RISO, INC. **PARTS CHANGE INFORMATION**

PART: BRACKET; LOWER LIMIT SWITCH **ISSUE #: 027**

NEW PART NUMBER: 011-11610 NEW DESCRIPTION: BRACKET; LOWER LIMIT SWITCH OLD PART NUMBER: 011-11610 OLD DESCRIPTION: BRACKET; LOWER LIMIT SWITCH	[ ] New [X] Modified [ ] Obsolete [ ] Other
Compatible: [X] Not Compatible: [ ] Old/Obsolete: [Y]

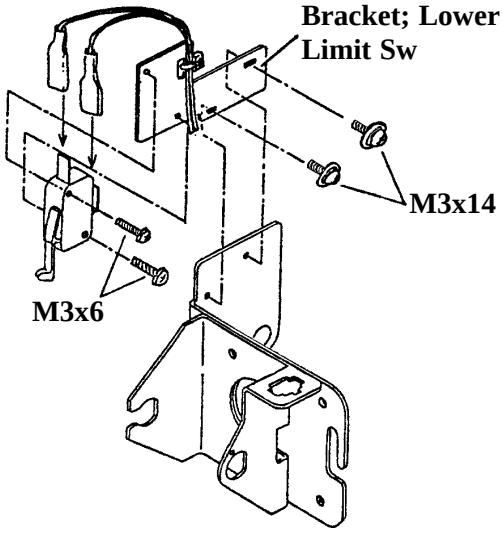
The Bracket; Lower Limit Switch on RC series machines has been changed to make the Lower Limit Switch adjustable, preventing T-2 failures in the field.

Push the bracket this way when securing it.
